# Correspondence Support

**RE: Case Number C814-86-023.01**

**RE: Shepherd Mountain / SPC-2017-0239C**

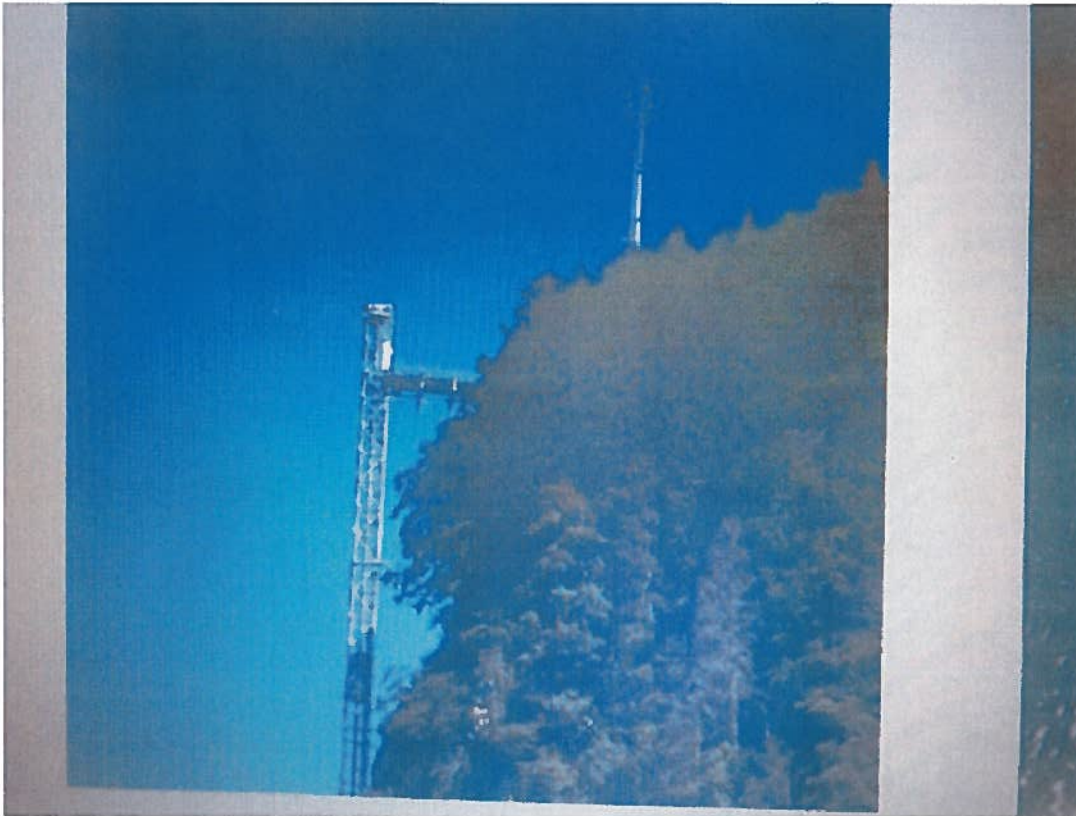
Mr. Coon is intending to build a 624' long marina on Lake Austin, the longest there would be. He is asking also for the possibility to extend it 100' into the lake, which is roughly 20% of the width of the lake! There will be no roads going into this marina, as the topography makes it impossible. The only access would be through a mechanical elevator that would be roughly 180' tall (~15 stories), that would connect to the top of the cliff with a bridge. The marina is planned to be good for 24 boats and would include: bathrooms, a swimming area, a kitchen, and 7,500 square feet of recreational space for "people to hang out".

I do not see how this monstrosity would address FIRE or EMS emergencies. No roads can be built on the vertical face of the rock rim. This place would be a fire trap next to acres of our urban forest, with no possible way to get to it, or out of it.

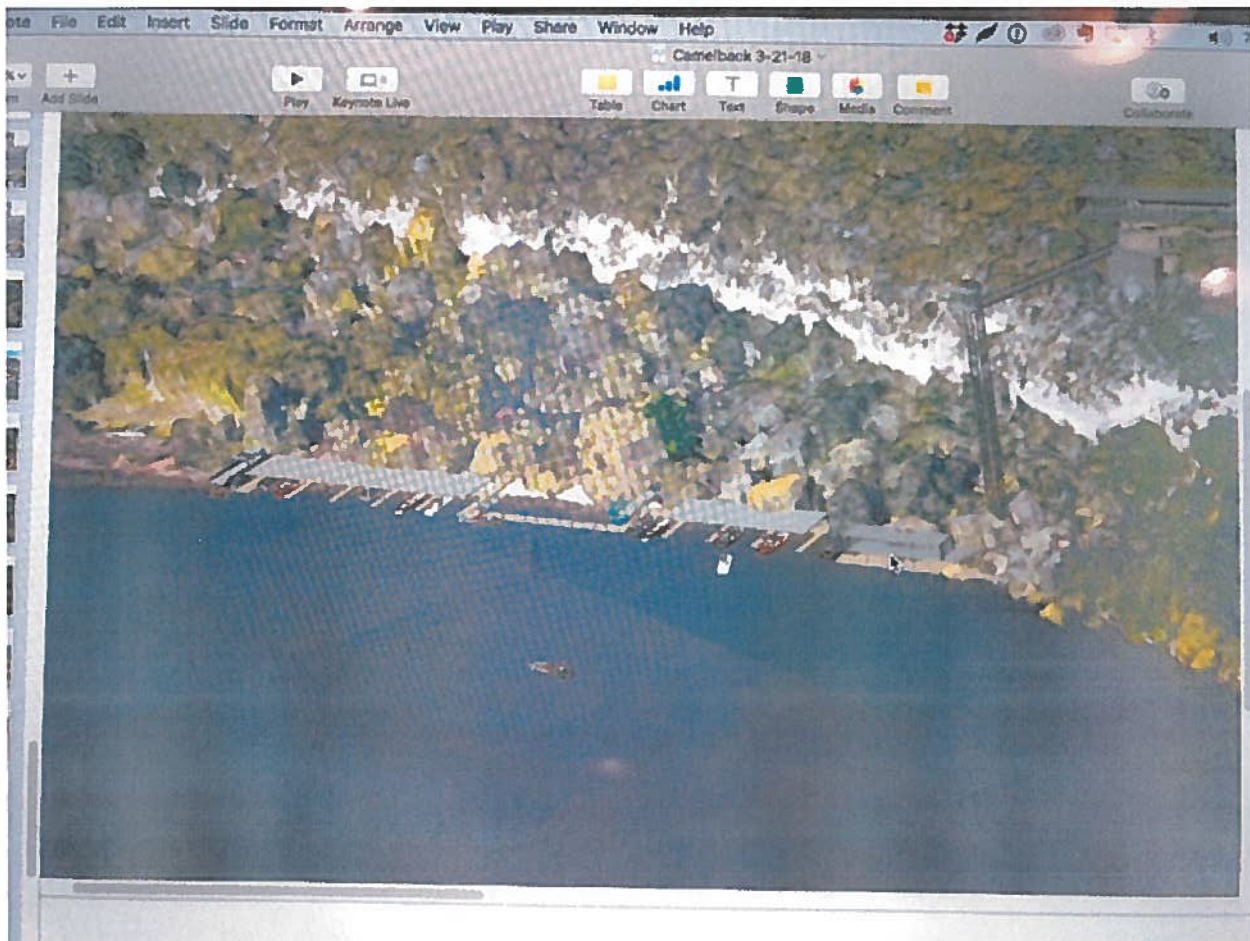
As I mentioned, Mr. Coon has been making public presentations of his project to a number of individuals. Some of his materials are available online on sites and pages that he created. I realize this is not in his presentation to the City, but this is straight from him and in my opinion should be used to construct an accurate representation of what we would be facing. You will find below some of his very own pictures. The first one is an actual elevator that he is using as an example of what he would build. I would add that water, trash, and sewer waste management would also need to be included, so in all likelihood his elevator is larger than this one.

The next picture is also Mr. Coon's. It is a computer generated rendering of his vision of this fire trap he intends to build. The elevator, the bridge to access it and the massive commercial marina with its party pavilion, kitchen and swimming area can be seen in it.

Can people cook and grill here? What happens if there is a fire? How quickly would that heavily vegetated vertical forest on the cliff go? Where are the mechanical rooms that move the elevator and pump the sewer waste up the hill? Are they electrical; can they catch fire? Are we facing biological hazards (bathroom on the lake)? Can people swim at this facility? How do you rescue someone in the event of a drowning accident, a choking incident, or any other emergency? Will the AFD engineering prevention department review the specifications of the elevator as to its suitability to carry emergency crews and equipment? How do you evacuate a stuck elevator? Who evaluates the elevator as a reliable and safe access to the boat docks (if functionality is compromised by either fire or mechanical problems during an emergency situation there would be no access or escape from the marina)? Are there fire lanes and an access road to the elevator including a turnaround area?

Exh 2  
Enviromental  
Review

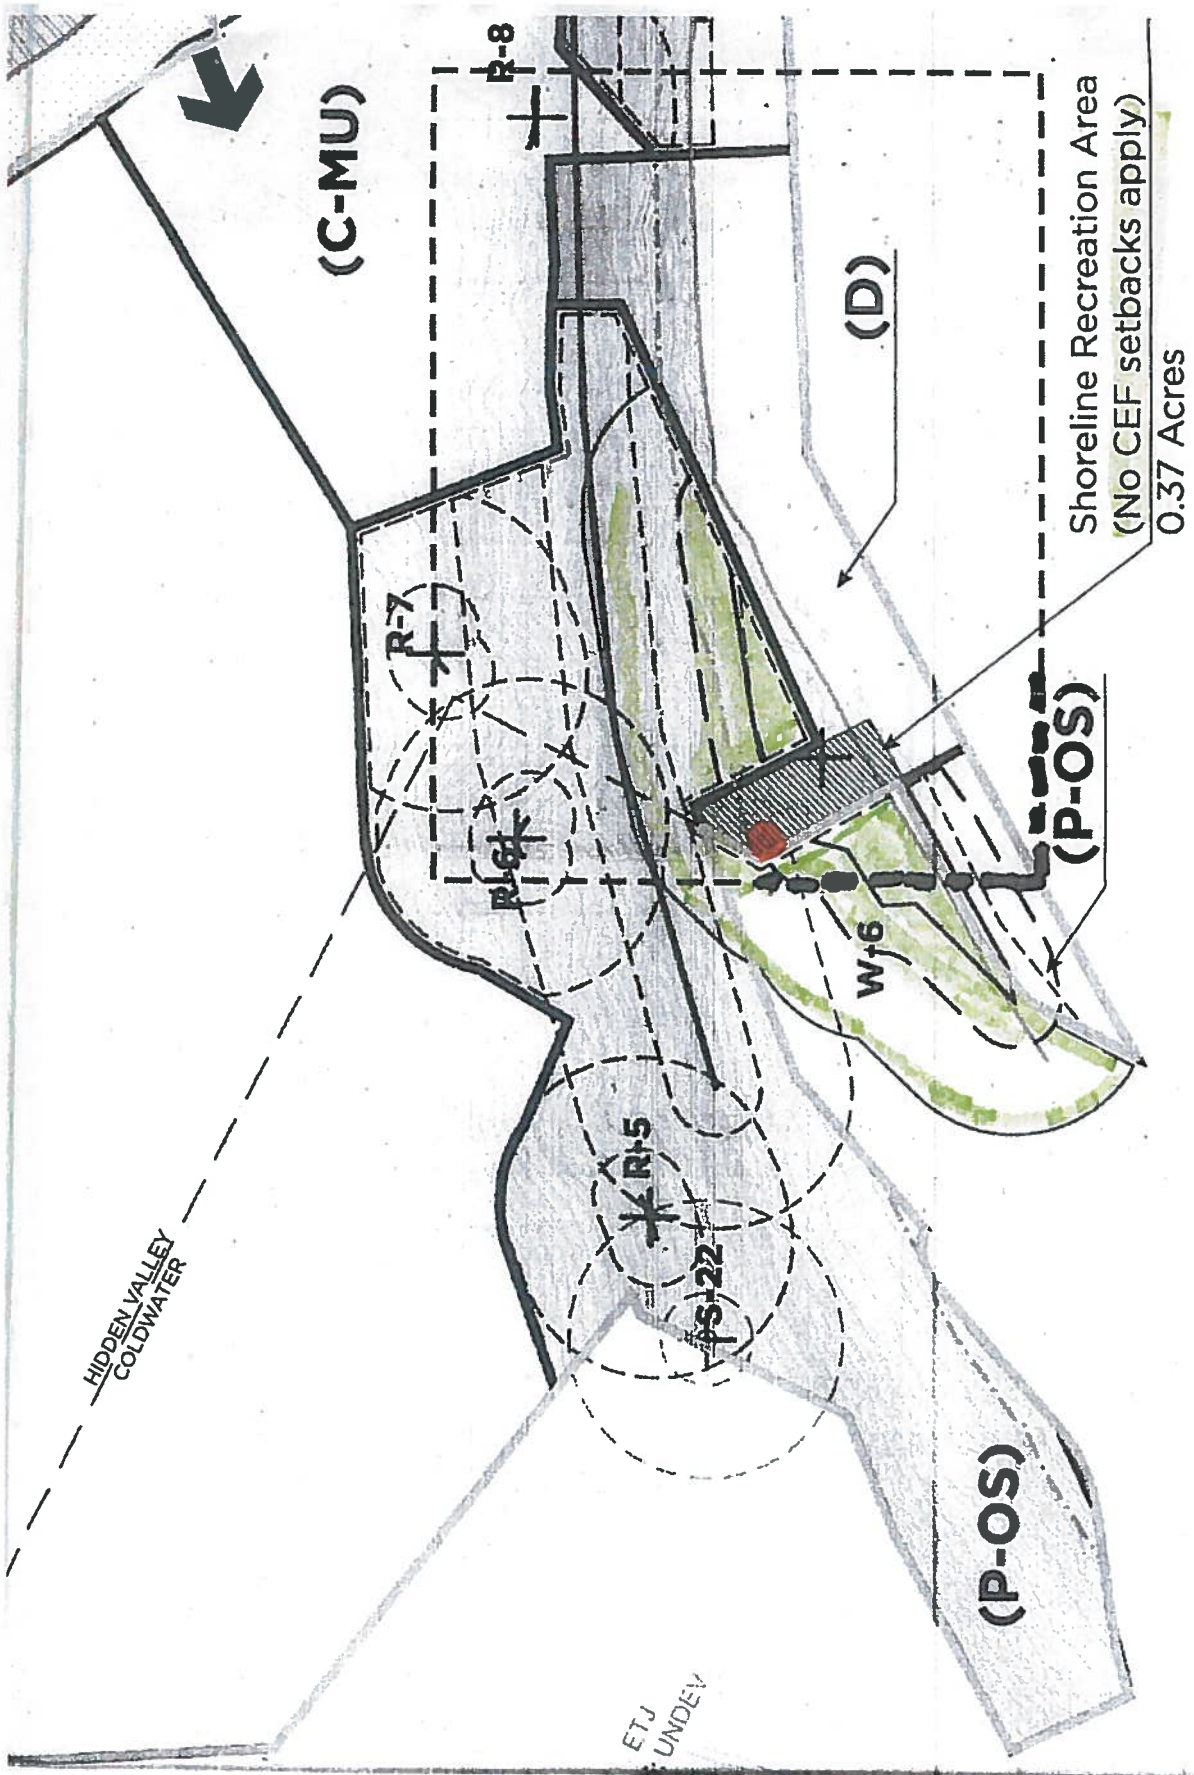
- "...creating a new wetland area along Lake Austin for 100 LF as described in Exhibit X." Wendy Rhodes P&Z case manager clarified Exh. X is really Exh. 2 (Applicant's Exhibit 6, page 3, "Other Environmental Benefits and Exhibit 2, Environmental Resource Exhibit). In my Exhibit, which is a copy of the Land Use Plan insert, "Dock Area Enlargement", I highlight the area in blue depicting the area described as "Wetland Restoration Area" from an insert on Exhibit 2 entitled "Wetland Restoration and Enhancement Areas. Mr. Howard, developer's attorney responded that the blue hatched area on Exhibit 2 was just showing water. If not then where is the "New wetland"? I contend, based on Wendy

Rhoades clarification and Exhibit 6, that this represents the 100 LF NEW wetlands and a new shoreline. Nowhere else do the Applicant's maps show water in blue hatch. What is the basis for the fill that is needed to create new wetland? Is the Applicant again stripping rights from the lots dedicated to parkland for the fill needed? Gift with no consideration anticipated. They are gifting lots to the City as a dedicated parkland. One of the legal criteria of a donation/gift is that the donor does not anticipate any compensation in return. Is the Developer stripping the rights from the donated lots and use the allowed amount of fill per lot to create a 100 foot NEW wetland.

- **Modifications reducing wetland and Bluff Critical Environmental buffer setback allowances. Specifically, CEF W-6.** (See Applicant's Map #2, "Environmental Resource Exhibit and 8-31-18 Planning & Zoning Response Comment Report, WB 11)
